REGIONAL REVIEW FINDING

RE: Development of Regional Impact (DRI) Review

Name of Proposal: NS Logistics South

<u>Description</u>: A Development of Regional Impact Review of a proposal to build 1,865,000 SF of warehouse distribution space in 4 buildings on a 306-acre currently wooded site with multiple stream areas in the City of Locust Grove in Henry County bounded by I-75 on the west, Bethlehem Road on the south, and the Norfolk Southern rail line on the east. The project will include 752 auto and 510 truck parking spaces and five stormwater detention ponds. Vehicular site access is planned via a proposed full movement driveway along Bethlehem Road; no alternative transportation access is envisioned. The local DRI review trigger is an application for a land disturbance permit; the expected build out year is 2026.

DRI

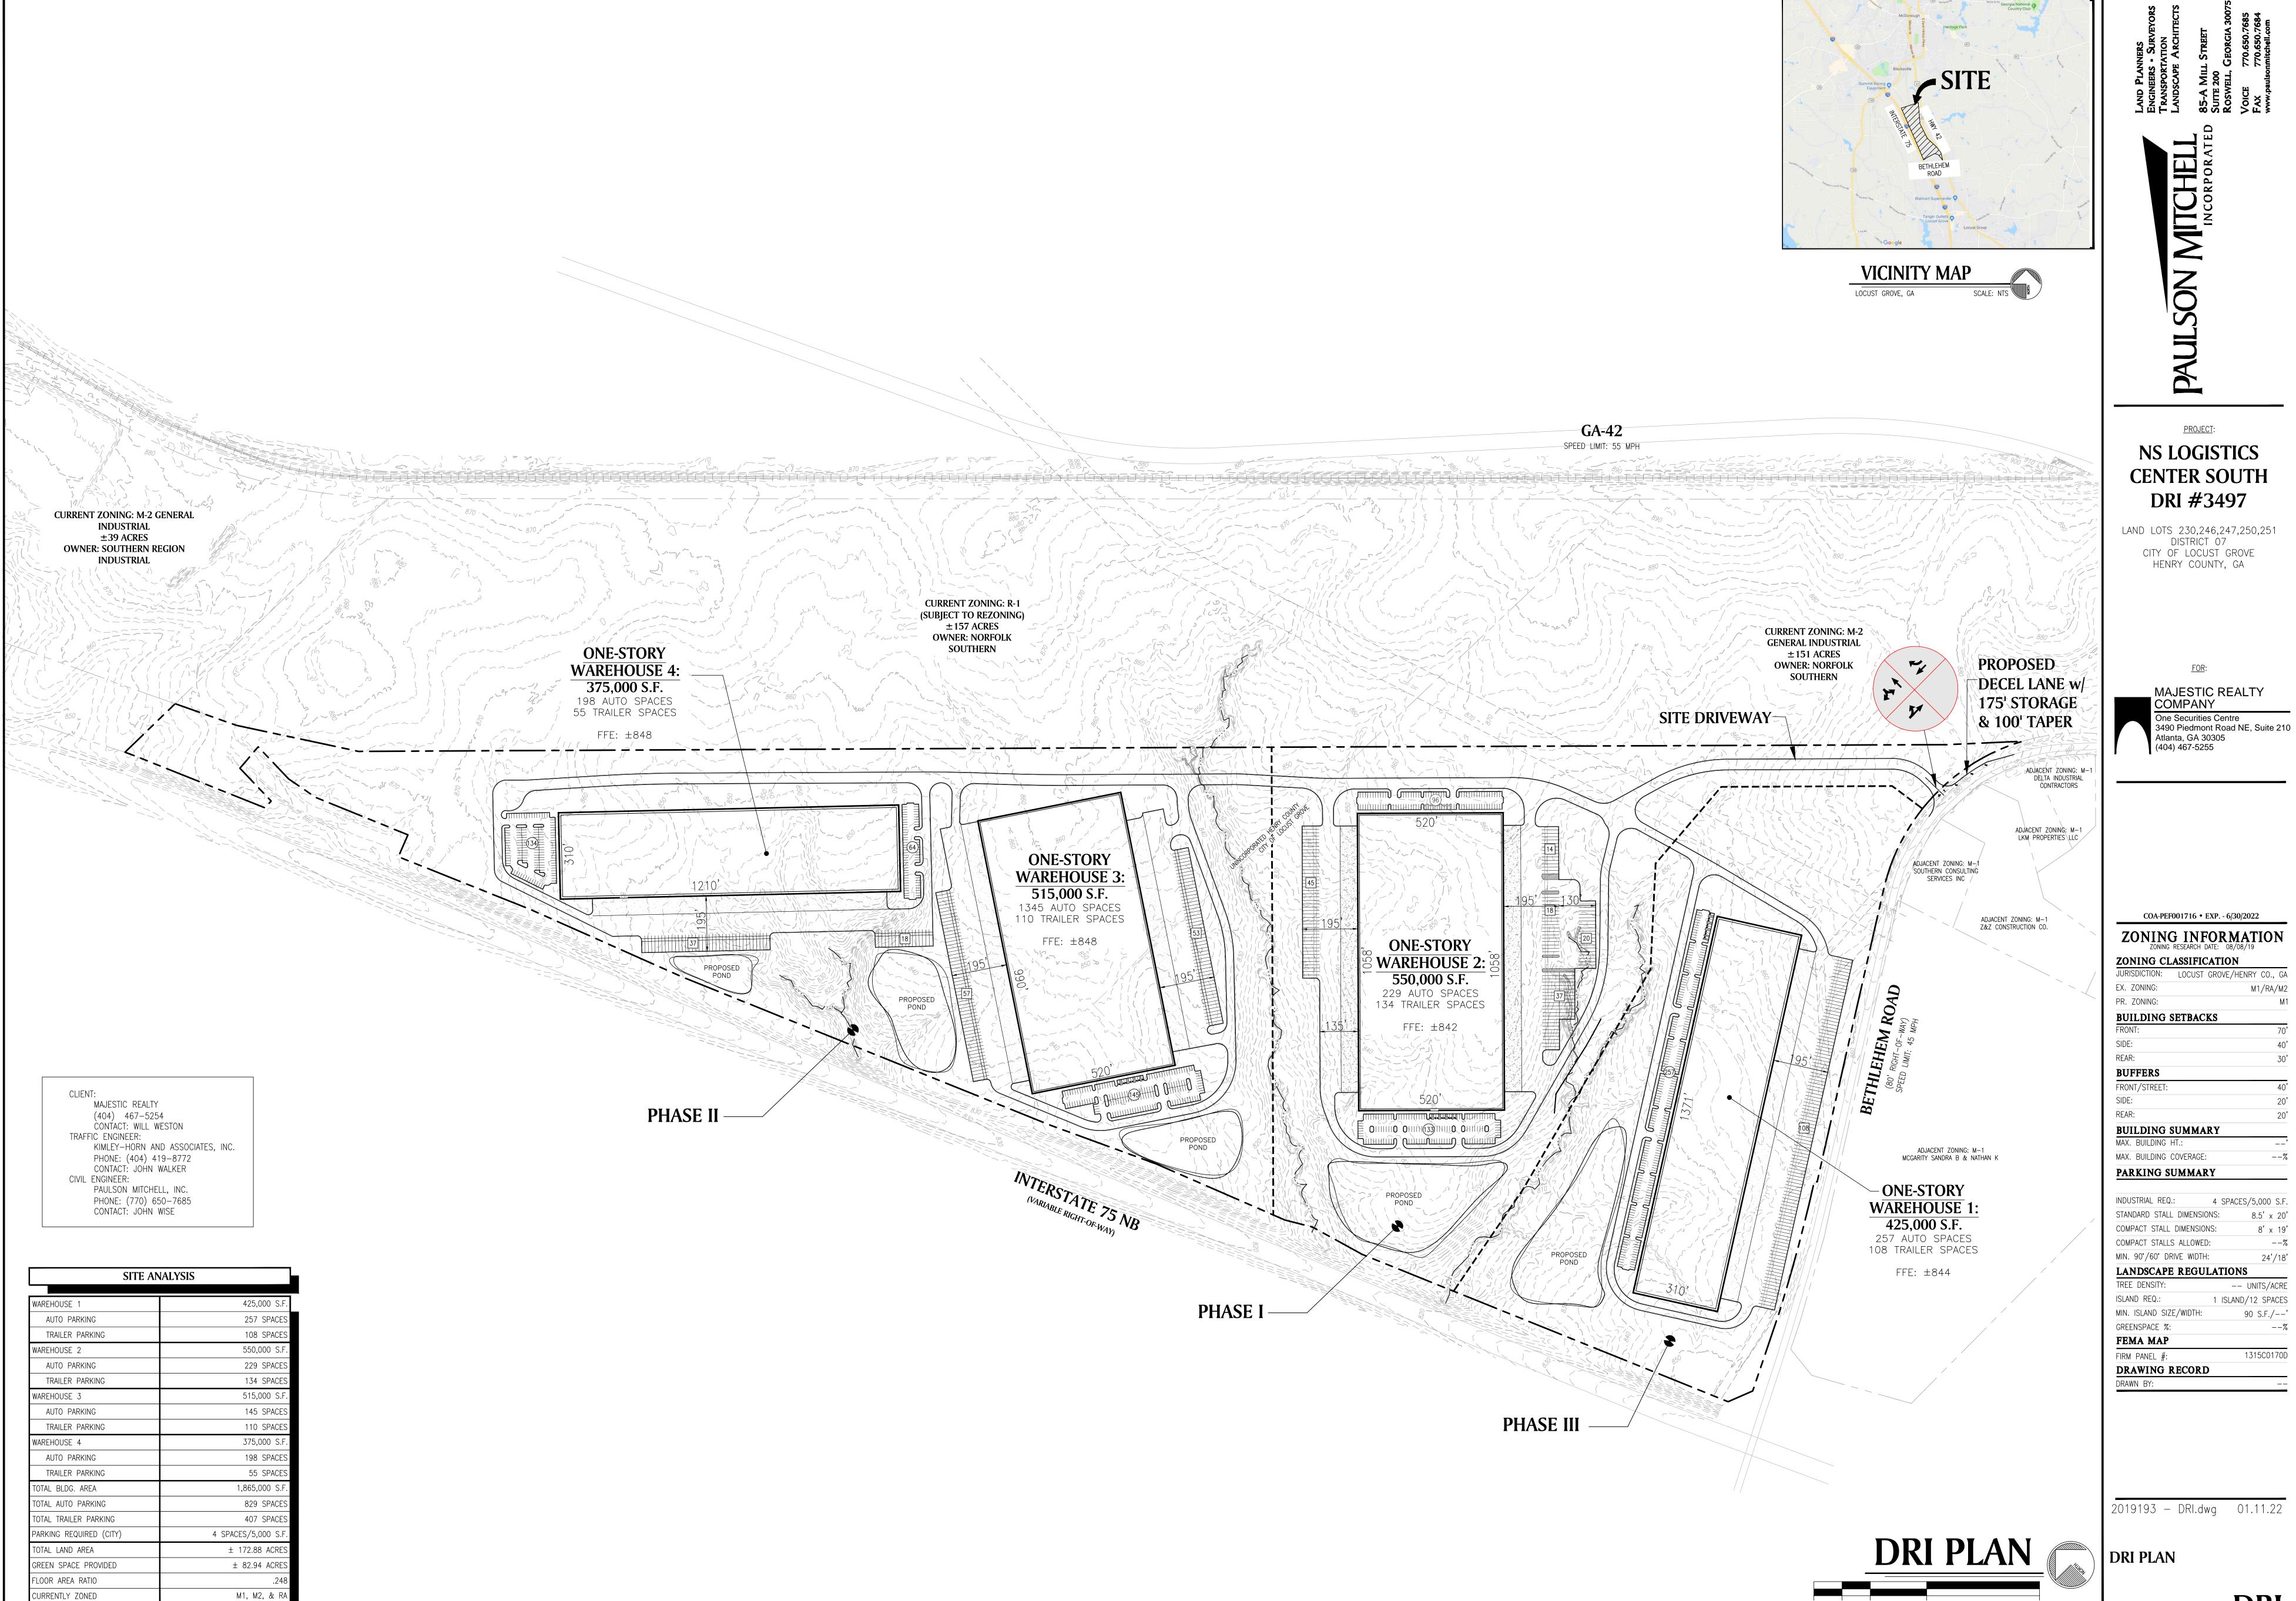
Stream buffer areas do not appear to be clearly shown on the site plan; some proposed parking areas and detention ponds appear to be in conflict with streams and stream buffers.

Three streams are shown on the project site plans and in general the development appears to be proposed away from stream areas. However, the site plan does not show the 50-foot buffer and 75-foot impervious setback required under the City Stream Buffer Ordinance or the 25-foot State Erosion and Sedimentation Act buffer. If the streams shown on the site plan meet the requirements for the City and State buffers, the buffers should be shown on the plans. The 25-foot State Erosion and Sedimentation Act buffer also should be shown on all streams on the property.

The site plan shows a portion of the proposed parking area for Warehouse Number 2 over a branch off the southernmost stream shown on the property. This parking area as well as any other proposed development in these buffers may require variances of the 25-foot State Erosion and Sedimentation Act buffer and the City stream buffers, if they apply.

Adjustment of proposed site layout to limit stream buffer intrusions would enhance responsiveness to Developing Suburbs growth policies, the Locust Grove Future Land Use Map, and Georgia DNR recommendations.
